Re: Approval of Red Hill AOC SOW Deliverable under Sections 6 & 7 – Revised Monitoring Well Installation Work Plan, July 17, 2016

ATTACHMENT 1 – REVISED FIGURE 2 - MONITORING WELL LOCATION MAP

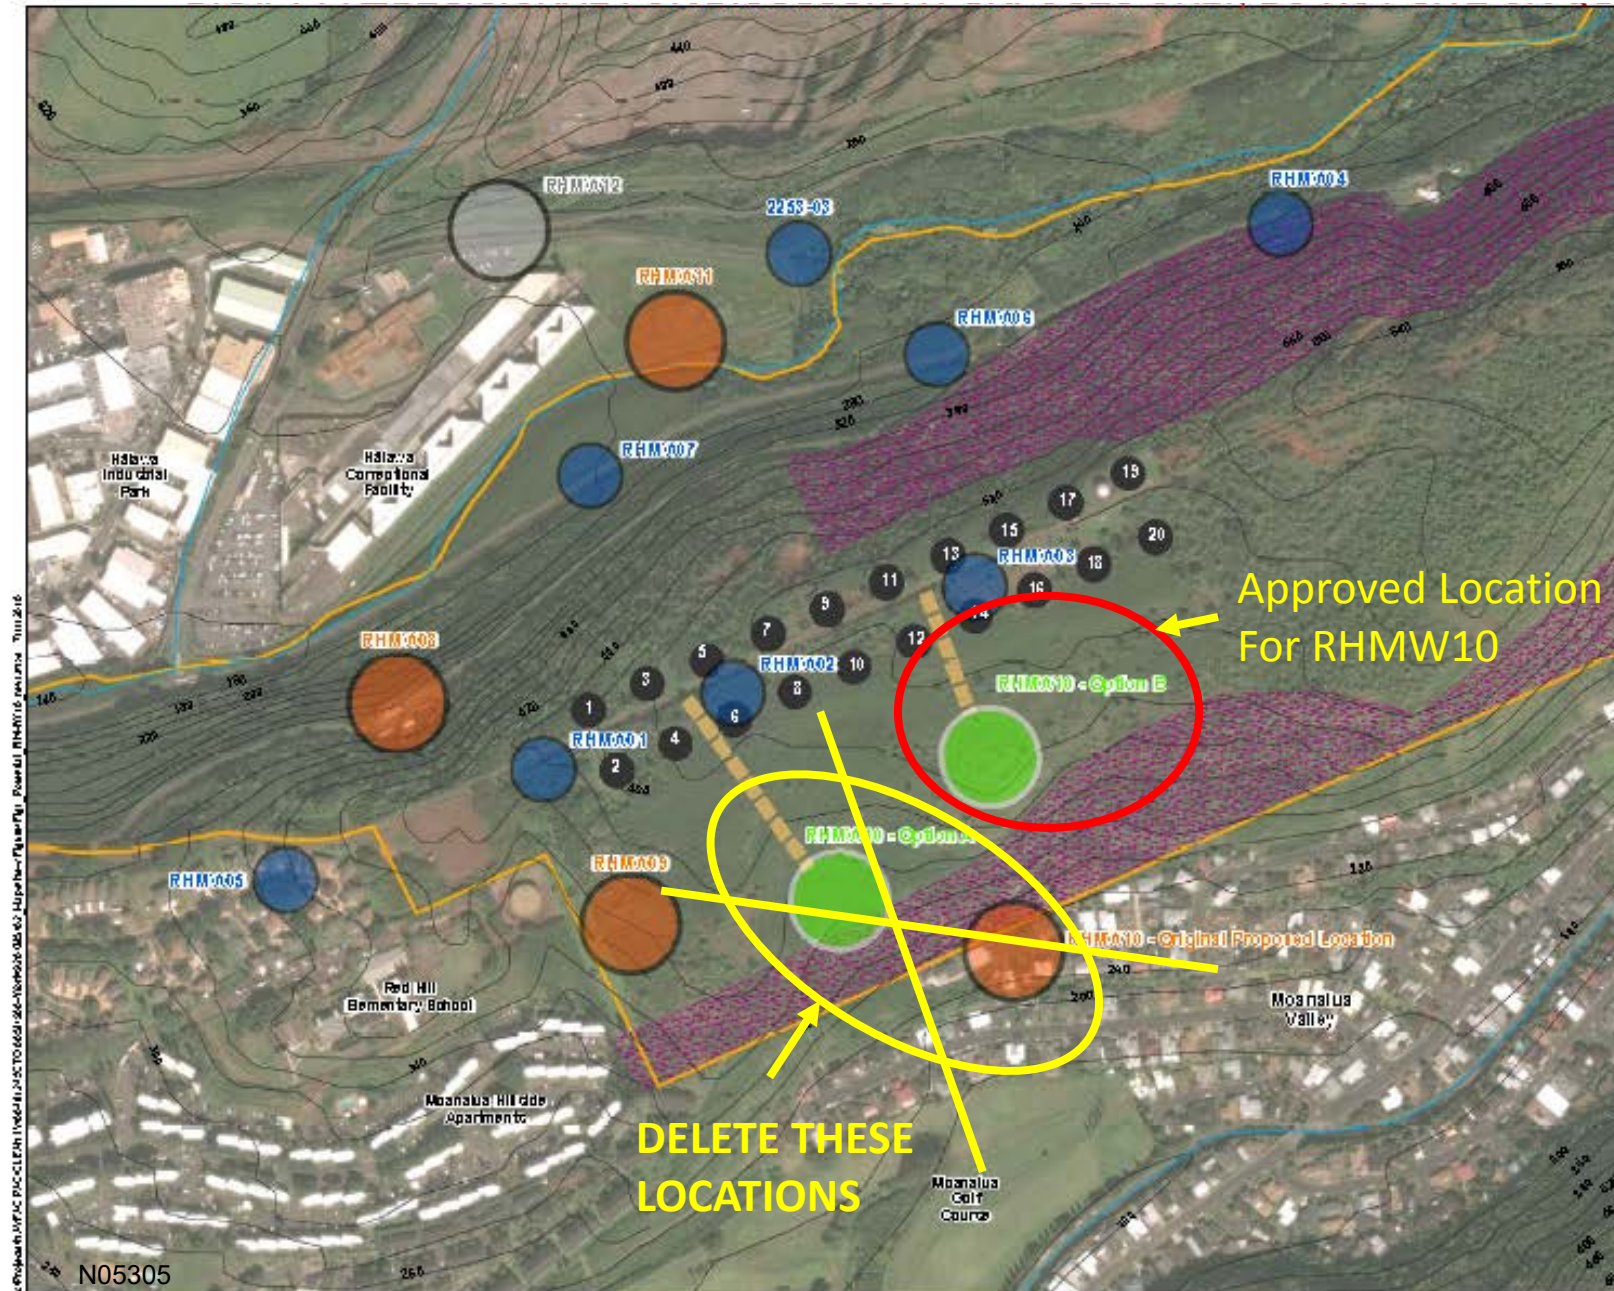
1. Regarding the location of Monitoring Well RHMW10, the Navy and the Regulatory Agencies held an extensive discussion on the location of this monitoring well during a July 8, 2016 teleconference. On July 11, 2016, the Navy submitted a new location map, entitled "Fig1_Potential_RHMW10 rev 4" that included the initial original proposed location of RHMW10 as well as two alternative locations labeled RHMW10-Option A and RHMW10-Option B. As discussed in the July 8, 2016 teleconference, the Regulatory Agencies believe RHMW10-Option B is the better location for this monitoring well. The Navy and DLA shall revise Figure 2 – Proposed Monitoring Well Locations of the MWIWP to show RHMW10-Option B as the proposed location for RHMW10. See Attachment 1 of this letter.
